CITY OF ALBUQUERQUE

**RE: Lot 12 Block 2 Unit 19 Volcano Cliffs SAD 228
6520 Camino Del Oeste NW
Grading and Drainage Plan
Engineers Stamp Date 4/5/17 (D10D003G12)**

ENGINEER'S SEAL	6520 CAMINO DEL OESTE	DRAWN BY WCWJ
		DATE 4-04-17
	GRADING AND DRAINAGE PLAN	21727-LAYOUT-4-04-17
		 <i>Rio Grande Engineering</i> 1606 CENTRAL AVENUE SE SUITE 201 ALBUQUERQUE, NM 87106 (505) 872-0999
4/5/17	JOB # 21727	
DAVID SOULE P.E. #14522

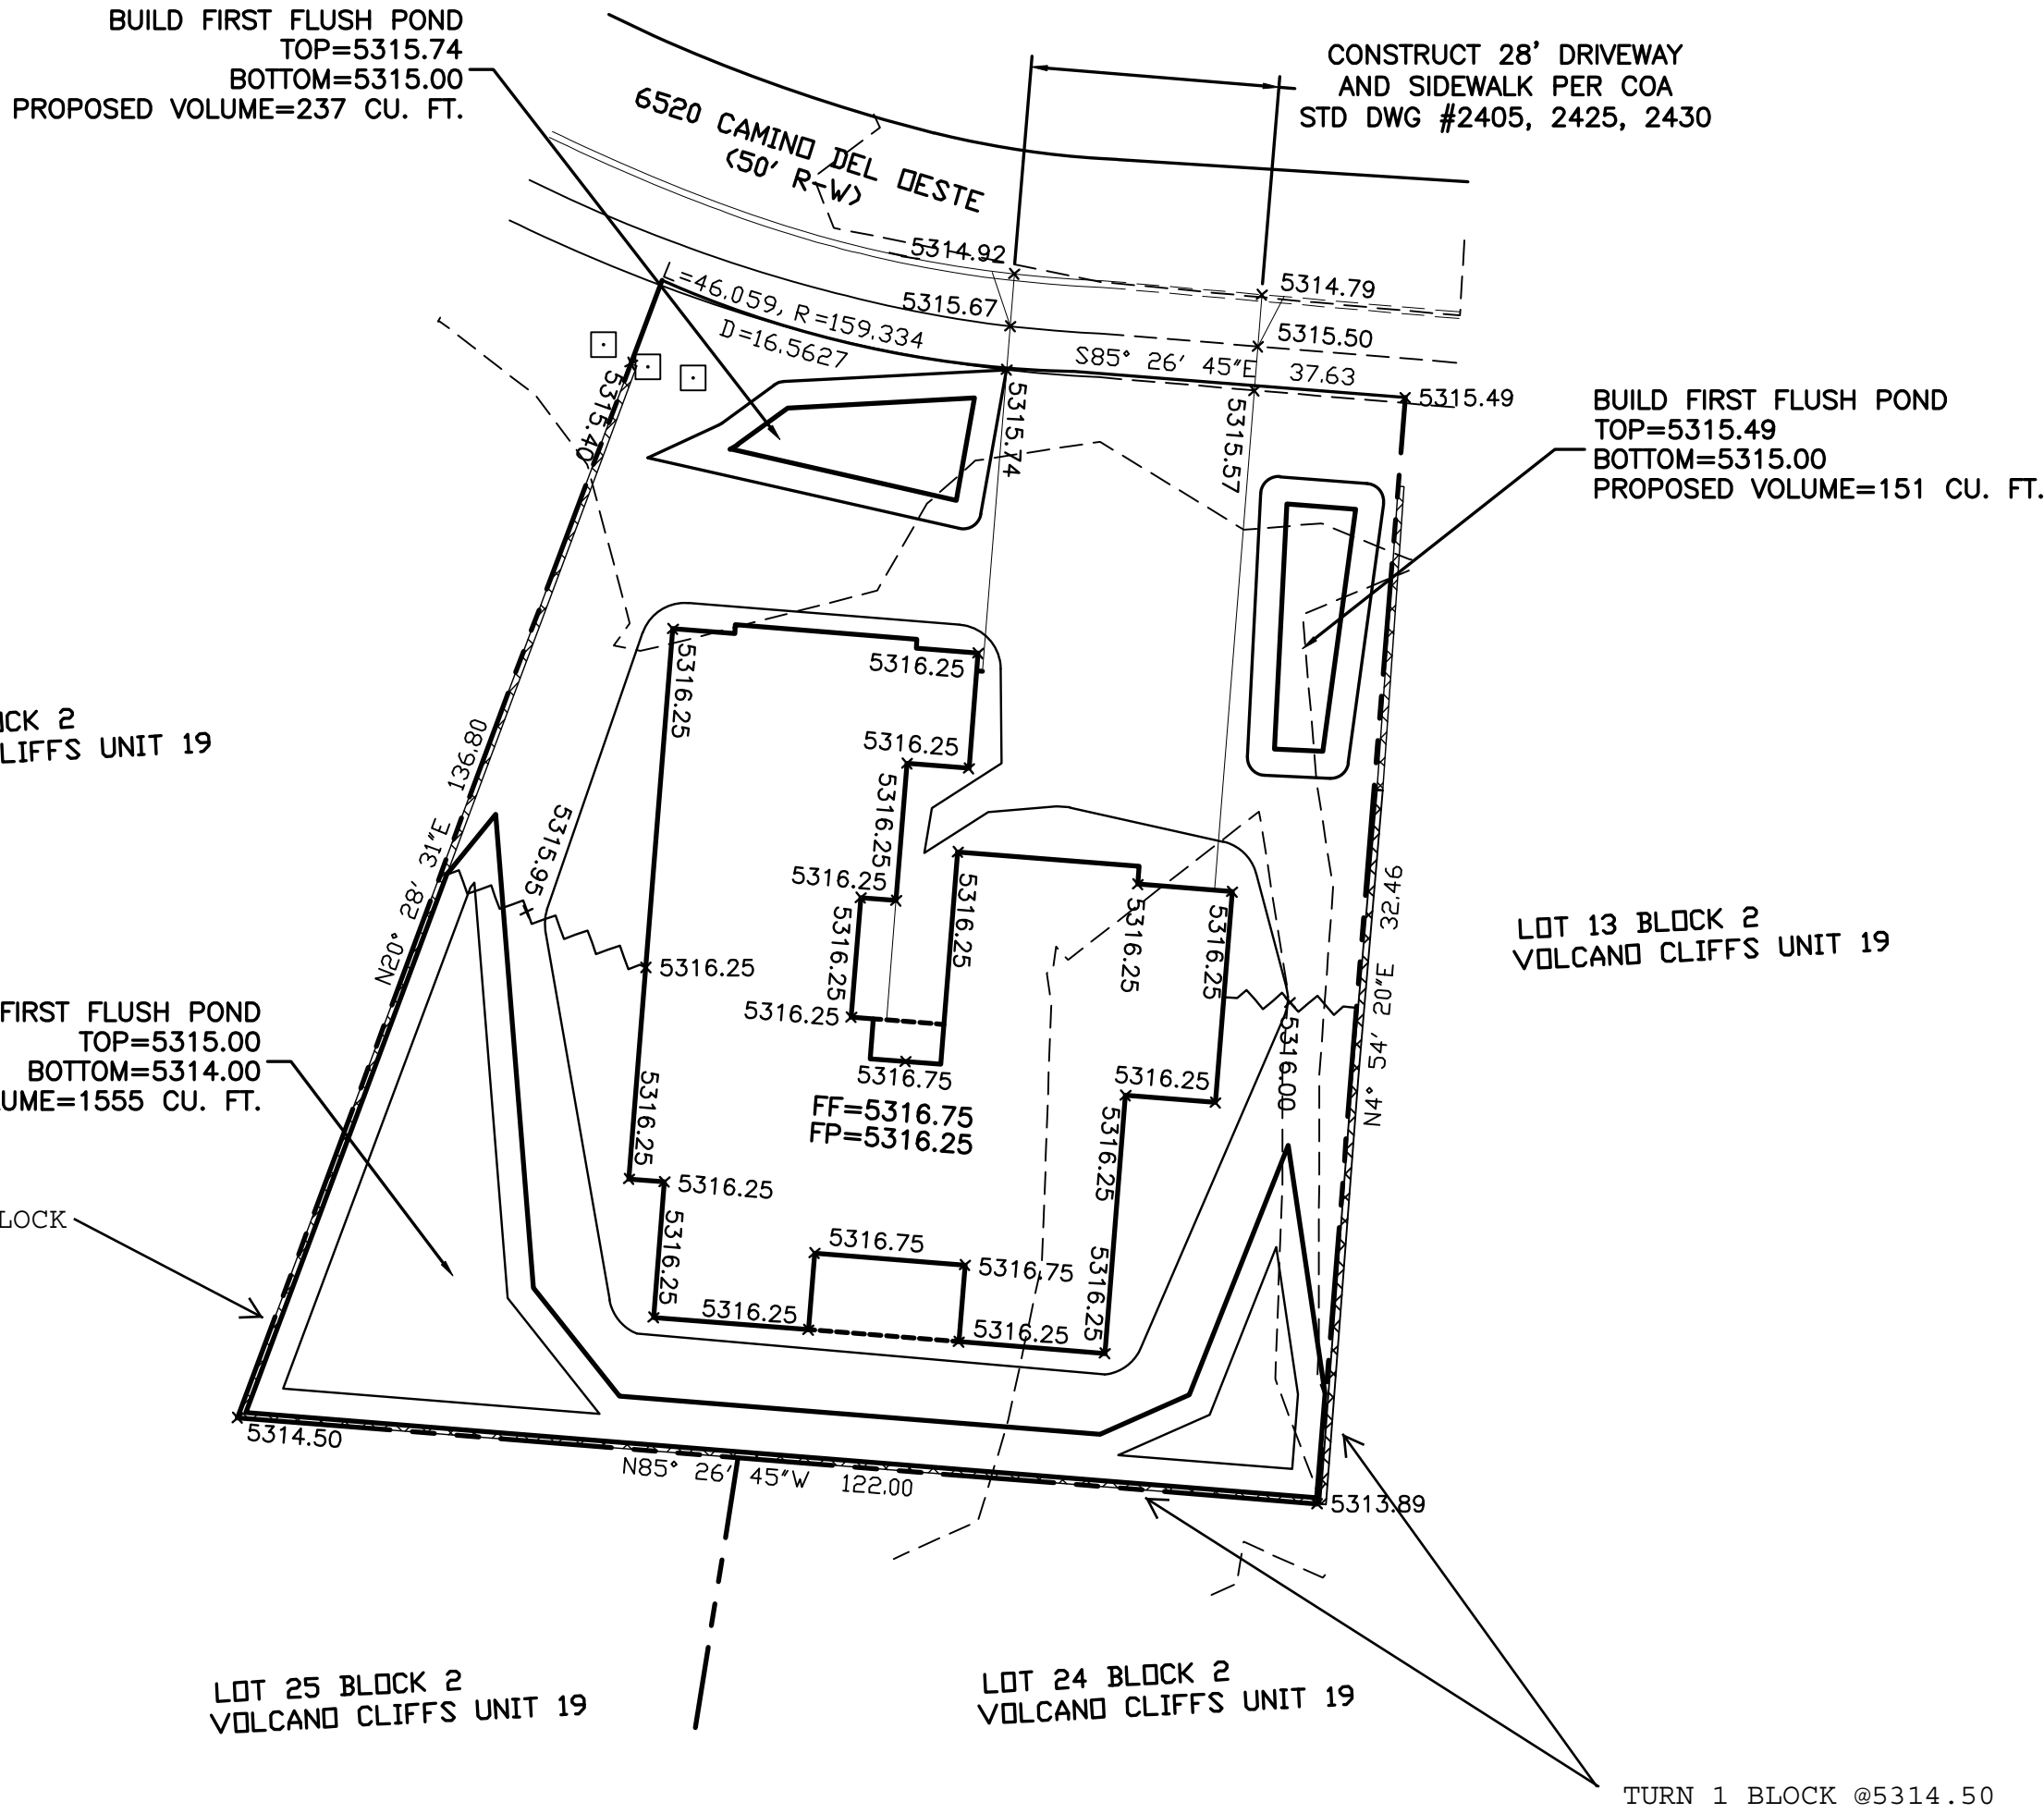
- All drainage to exit front yard via first flush pond.
- Removes openings in block wall.
- Remove statement for cross lot drainage.
